Reference: L-2024-051816-A

Subject: Invenergy Clear River Energy Center  
Facility Noise and Community Noise Impacts

Subject: Invenergy Clear River Energy Center  
Additional Comments on Facility Noise Issues

Subject: Invenergy Clear River Energy Center  
Invenergy Peer Review Responses on Noise and Community Noise Impacts

Figure 1

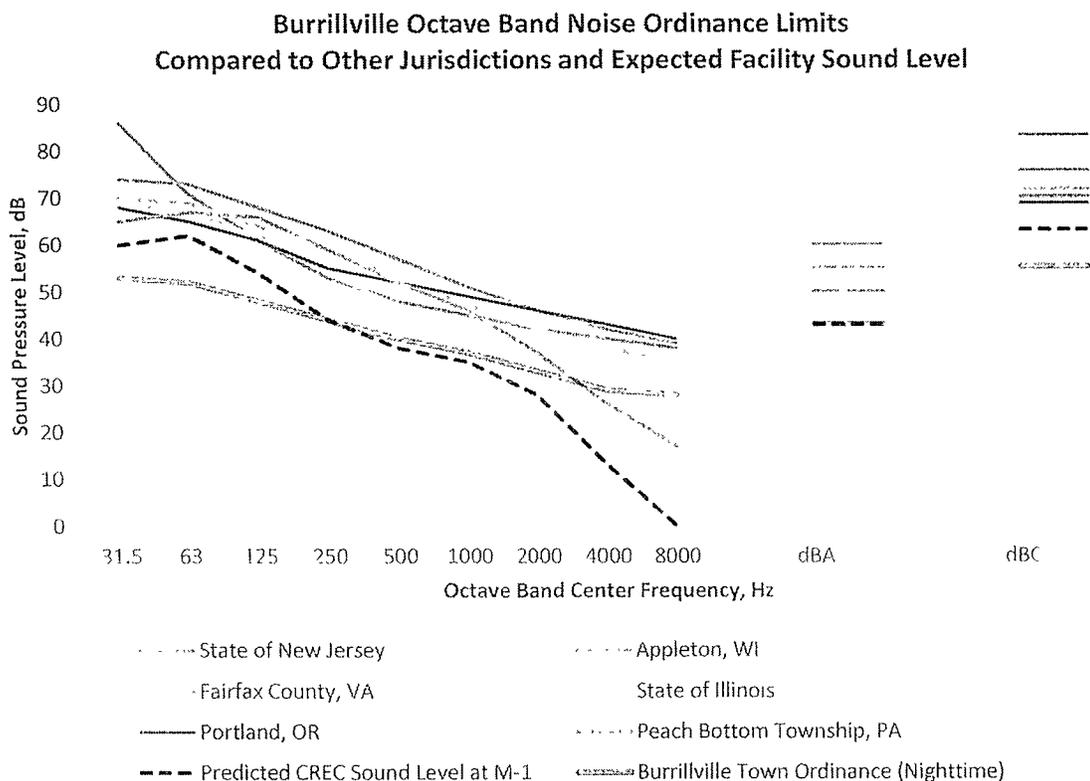
In addition to this it is important to realize that the octave band limits contained in the Town Ordinance, especially in the lower frequencies, are well below all the other octave band regulatory limits that we're familiar with. The chart below shows a series of nighttime octave band noise limits from a variety of jurisdictions compared to the Town's limits (thick red line).

This graphic shows that the Town's limits are well below what might be considered the norm, but, more to the point, there is no actual need for the limits to be this low. The expected plant sound level at the closest residences is shown as the blue dotted line. Although it's not intuitively obvious, the plant would not be any less audible or sound any quieter if its sound levels in the three lowest octave bands were equivalent to the Ordinance rather than over the limits as currently predicted because, in a nutshell, the human ear is not very sensitive to frequencies below about 200 Hz, so the facility would effectively sound the same either way. In fact, subjective audibility is basically quantified by the overall A-weighted sound level and both the Ordinance spectrum and the plant sound spectrum in the chart both total up to 43 dBA, indicating that the sounds are of the same subjective magnitude. This overall limit of 43 dBA fully serves the purpose of limiting the project's noise to an acceptable level in the community. Invenergy has repeatedly argued that it is not feasible to meet the lower octave band limits and they have asked for a waiver on the octave band requirements. This is a legitimate assertion and a legitimate request. We would agree that it is probably technically impractical - and would add that it would do nothing to reduce the subjective audibility of the plant if it were.

Figure 2 Typical ACC Steam Duct

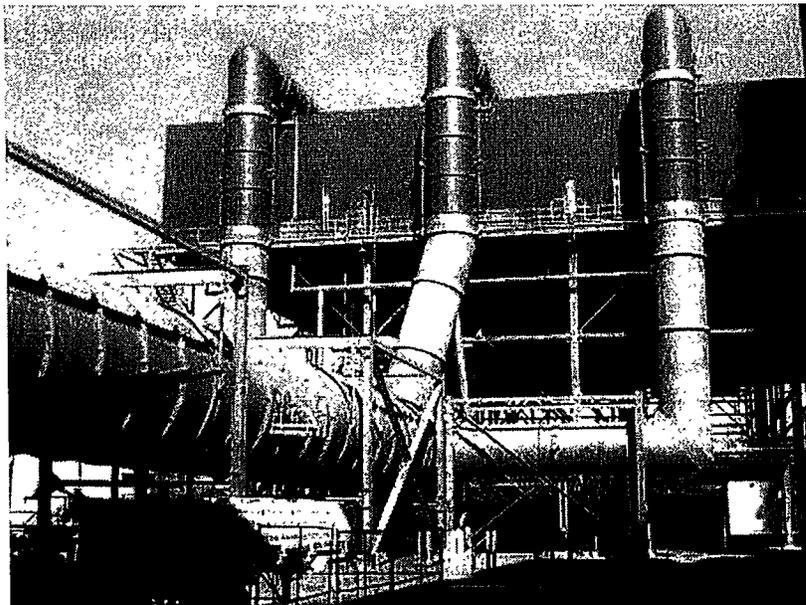
Consequently, while not all that unusual, we would fault the Applicant for avoiding any mention of start-up noise in their initial noise study for the important reason that the plant will employ air cooled condensers (ACC's). In our experience, ACC's are particularly prone to extremely high noise levels during start-up because very high pressure steam, not yet suitable for introduction into the steam turbine, is bypassed directly into a cavernous duct leading to the condenser (Figure 2). Because this duct is maintained at less than atmospheric pressure by vacuum pumps and noise generation over a valve is largely proportional to the pressure differential, it is quite difficult to keep this process, essentially a continuous explosion, quiet, even with "low noise" valves.

To their credit, when queried about this issue through the data request process, Invenergy did the right thing and commissioned an additional, detailed noise modeling study to evaluate the sound emissions from the facility specifically during start-up and steam turbine bypass. We have reviewed this new study and consider it competently done; however, the model inputs representing noise from steam turbine bypass into the condenser duct appear to be rather optimistic and much

Figure 1 ACC Steam Duct Enclosure Under Construction

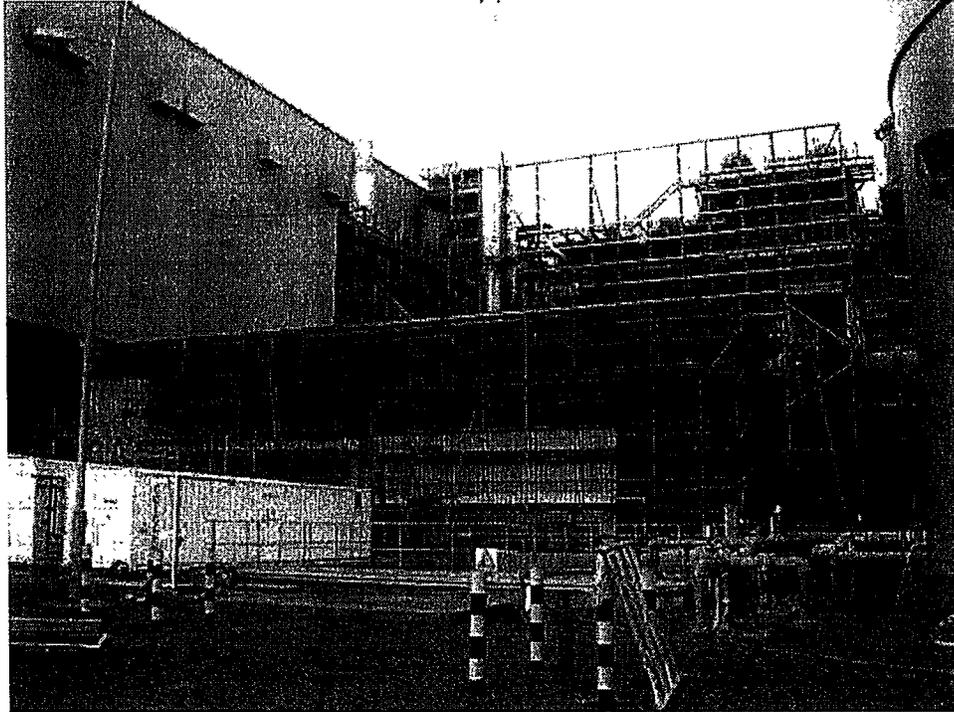
If a field test is impractical then I would ignore the guarantee and assume that the steam duct sound level will be in the 95 to 100 dBA range during bypass (based on past first-hand measurements of ducts using CCI low noise valves). The mitigation required for such a situation would probably involve a free-standing rigid enclosure over the initial (Figure 1) or entire horizontal run and lagging on the vertical risers. However, the appropriate amount of attenuation for each section or component must be calculated through analytical modeling.

If field testing or design assumptions suggest an enclosure, it should be built along with the rest of the plant and not held back as a potential retrofit, since that would create a period during which start-up noise would presumably be non-compliant.
